ADDENDUM 2

CSP 22-68

Memorial Middle School Heating & Air Condition (HVAC) Improvements Funded through the Elementary & Secondary Emergency Relief (ESSER) Funds

April 8, 2022

3 LEVEL 1E DEMO EXAHU-17
MD3.12 1/4" = 1'-0"

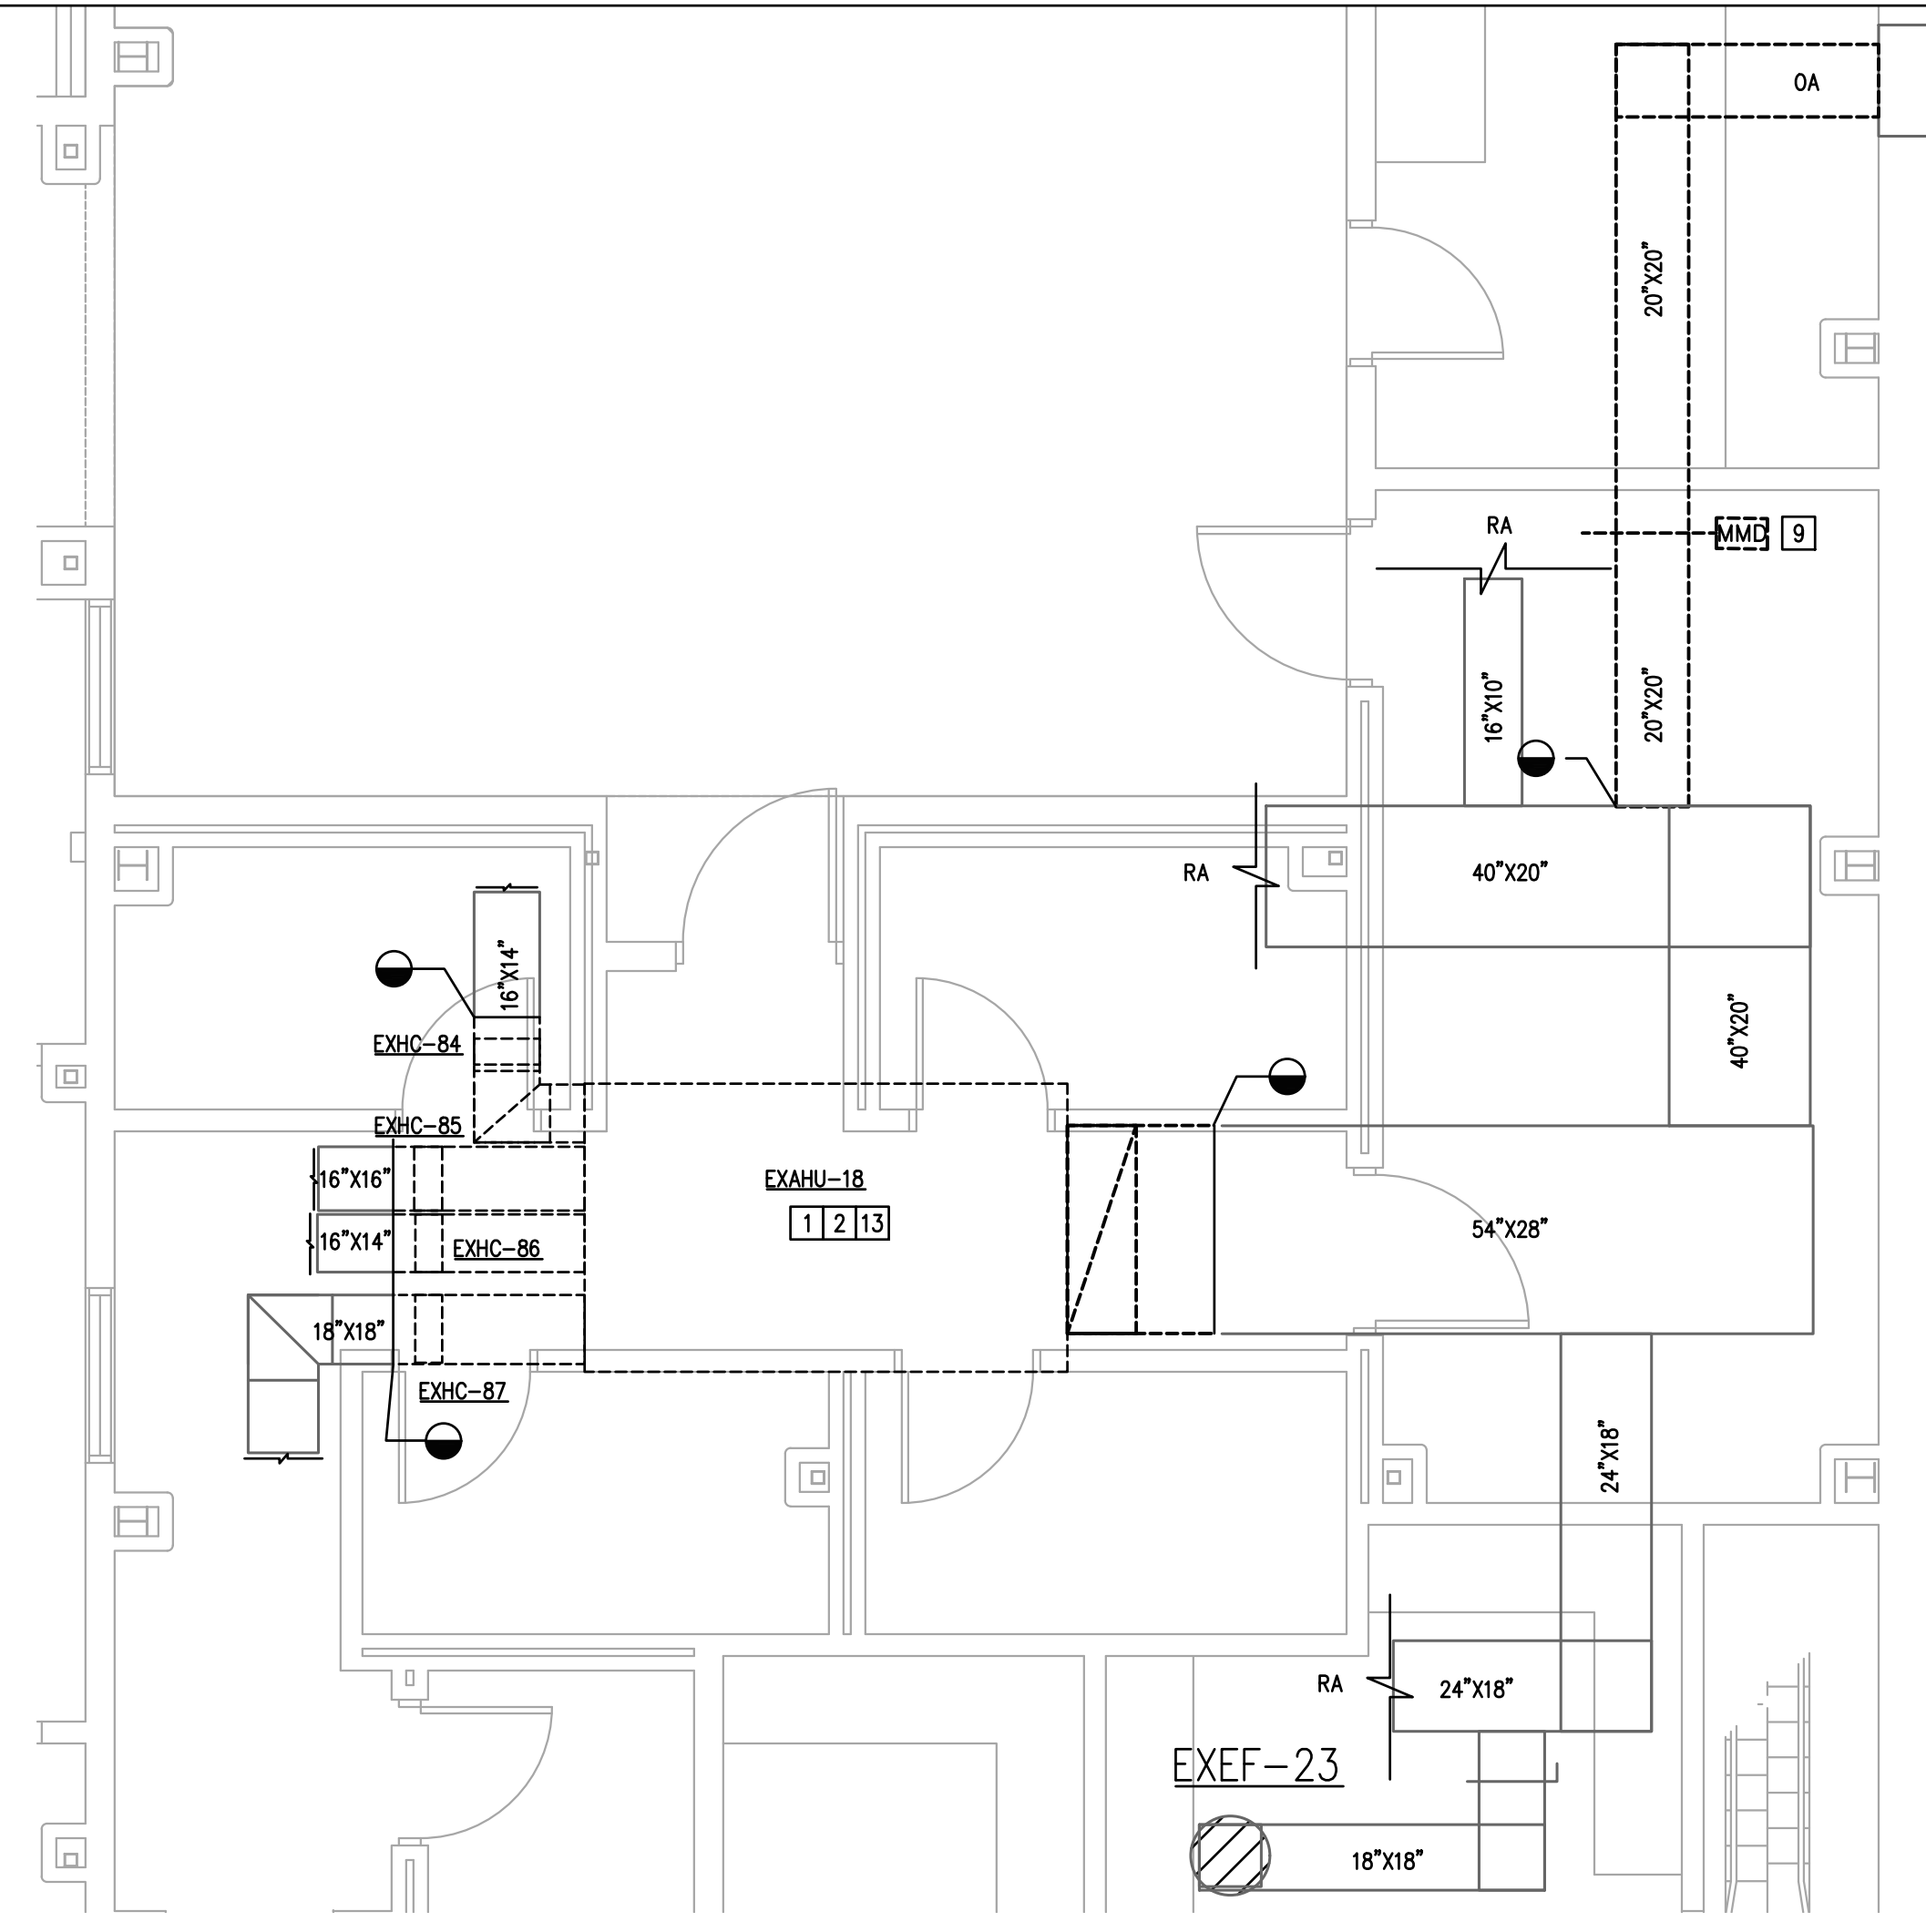
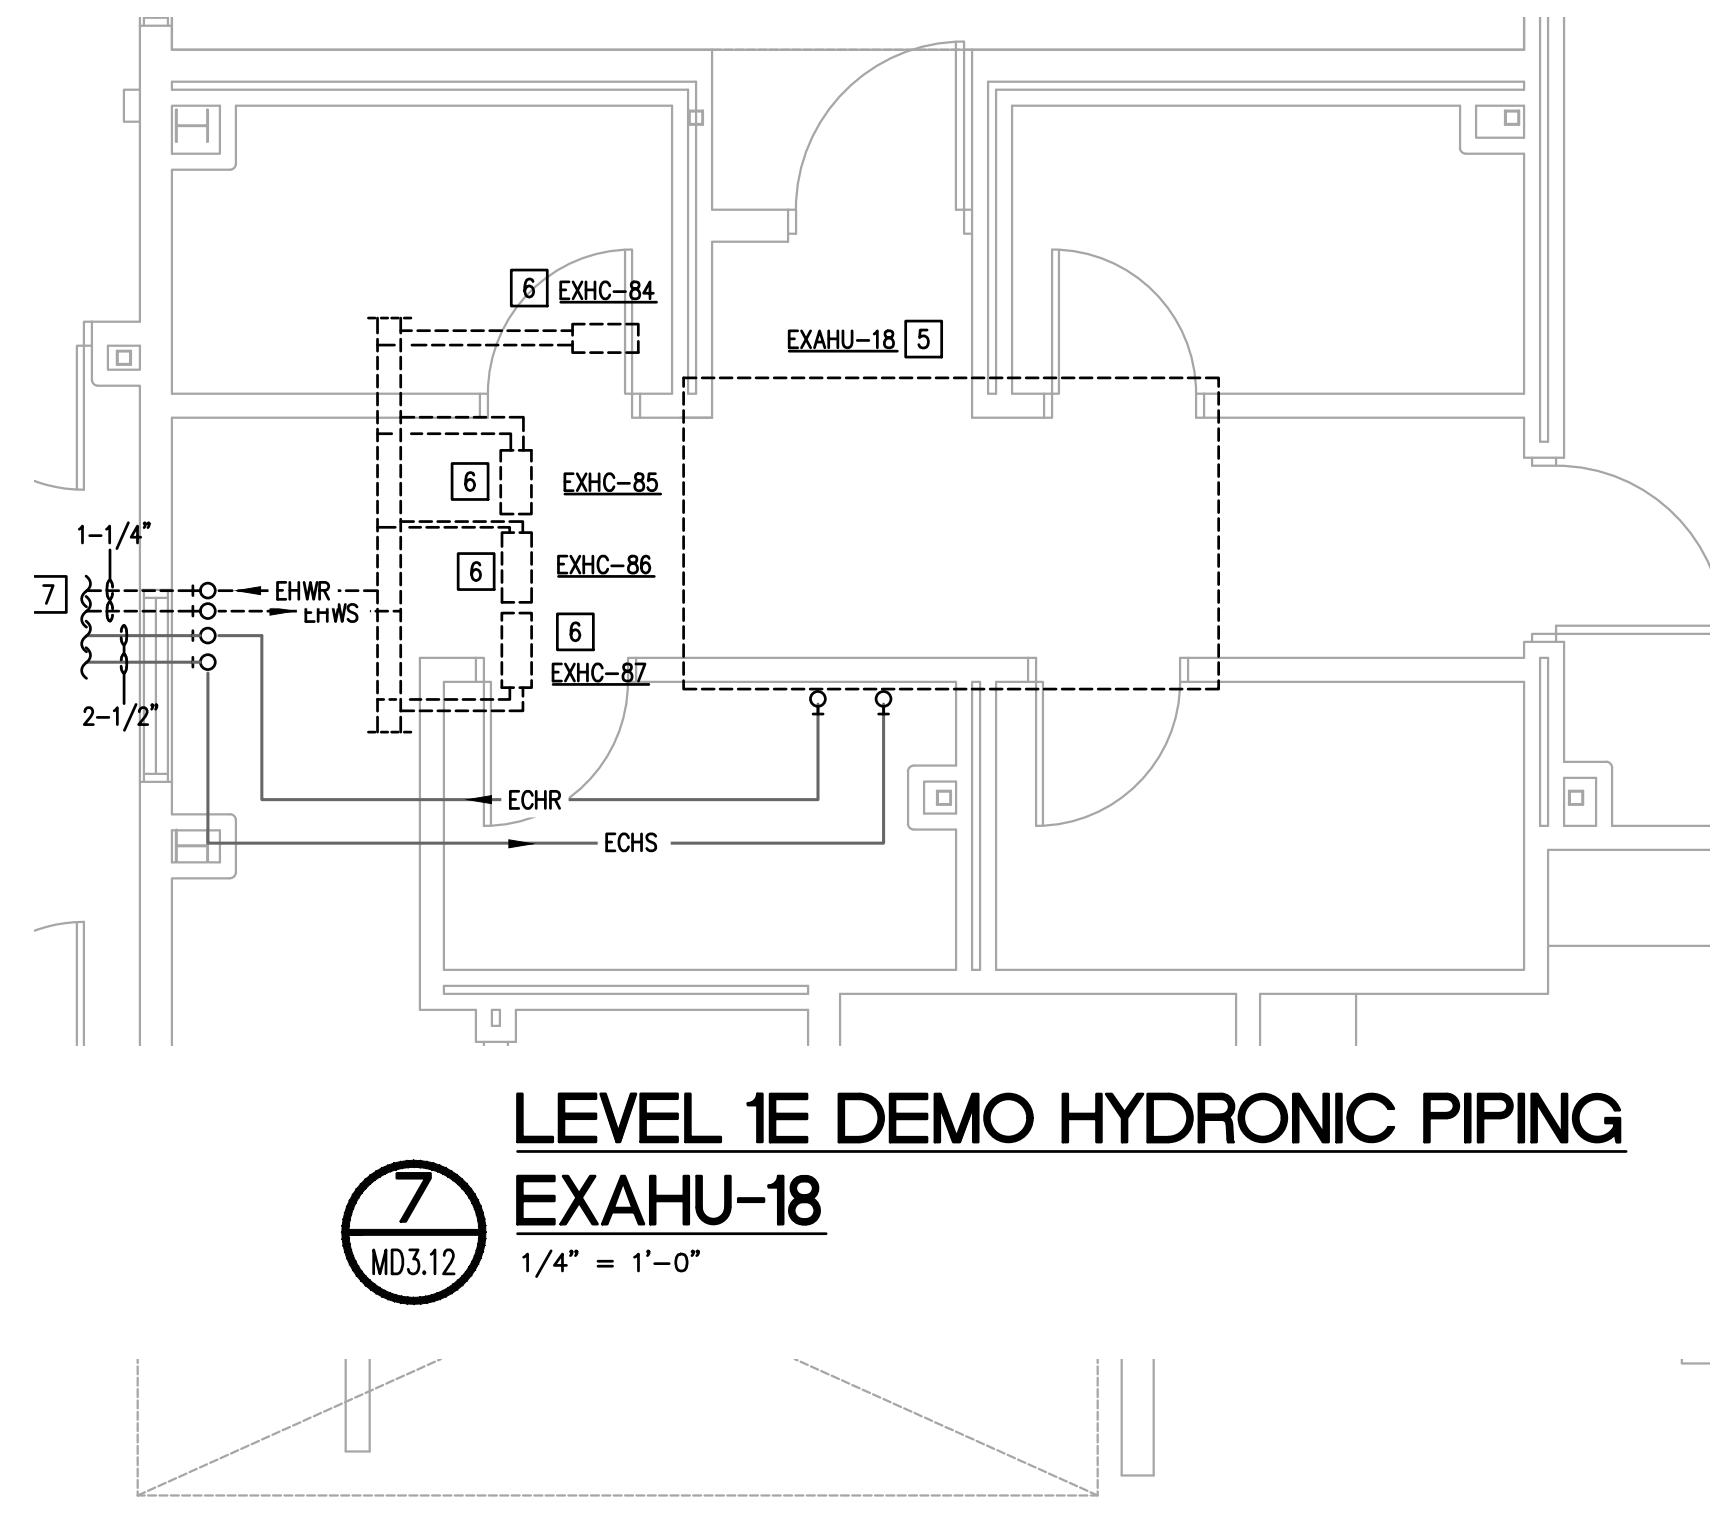
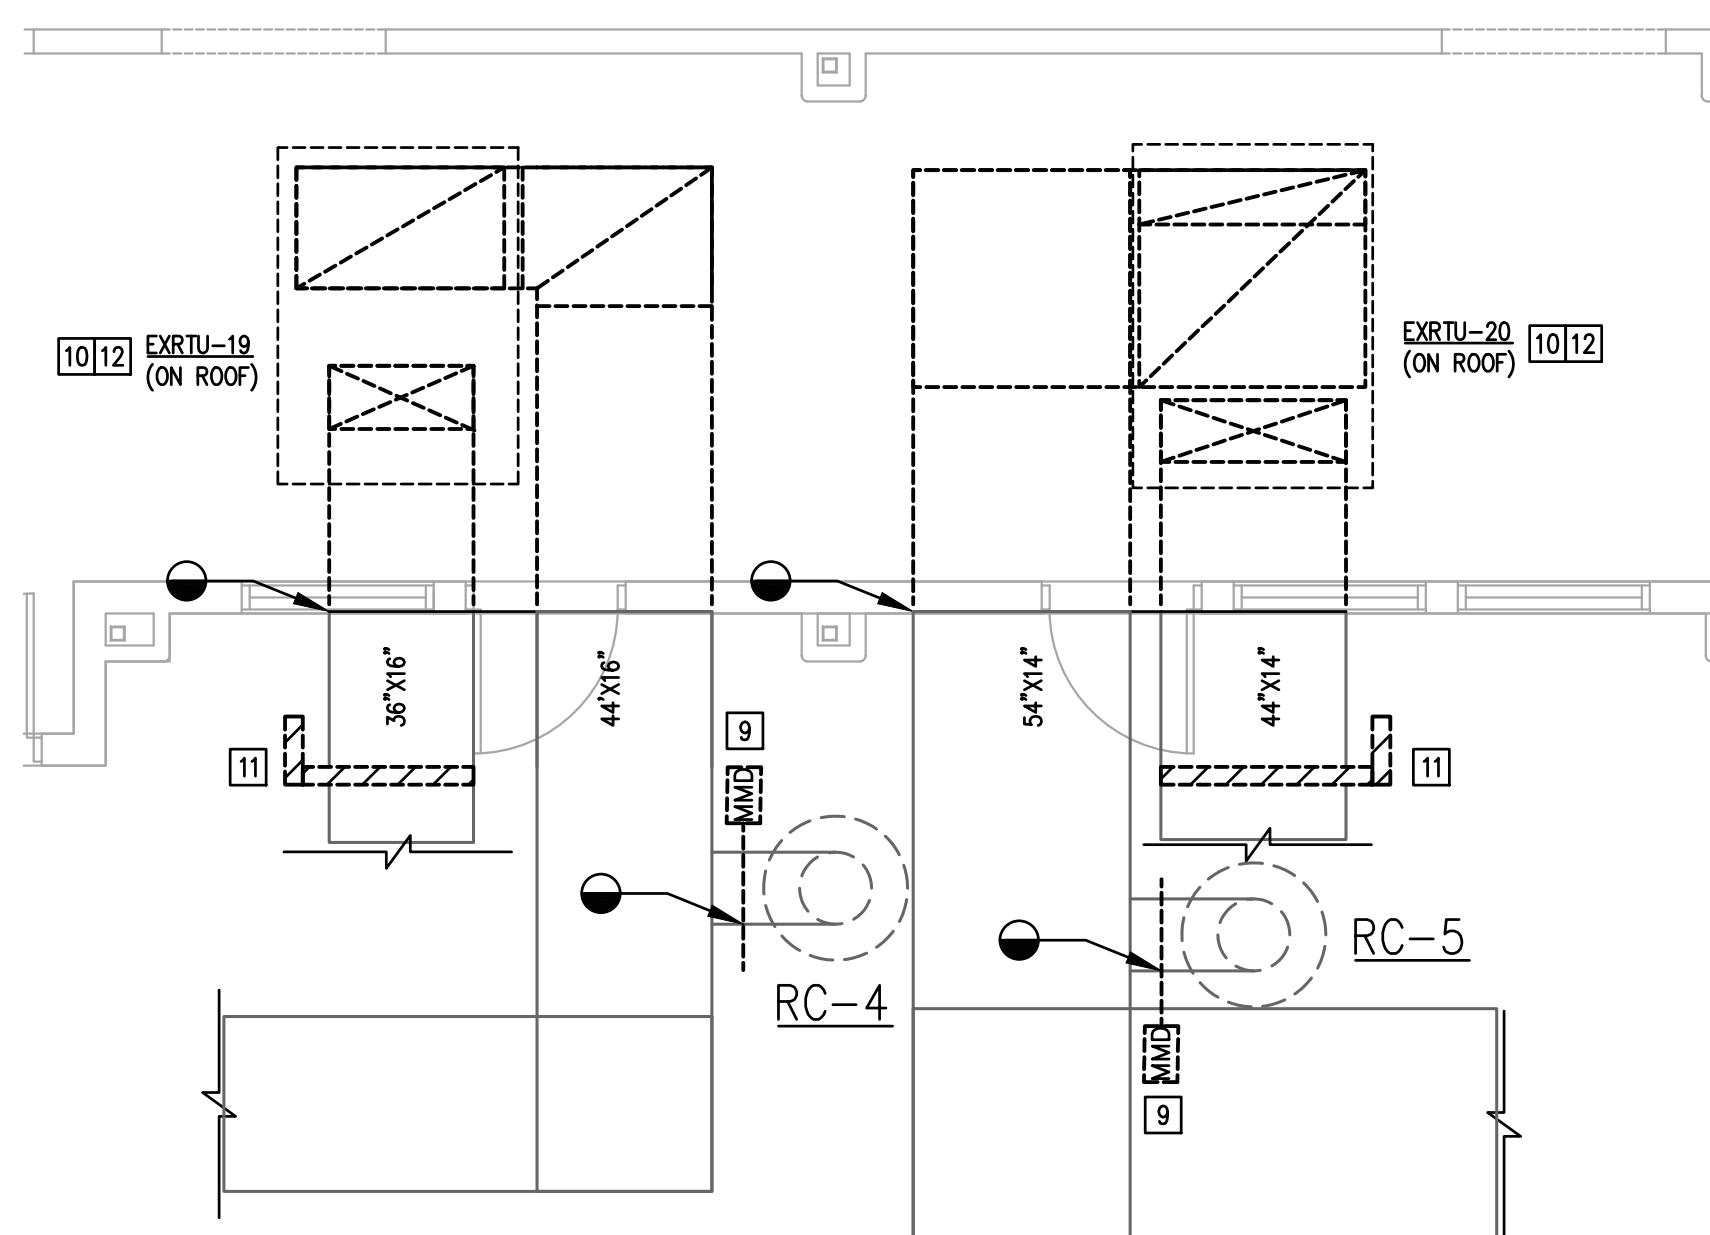
Item 05 SHEET MD3.12 – ENLARGED MECHANICAL DEMO PLAN

A. Revised keyed notes 3 and 10.
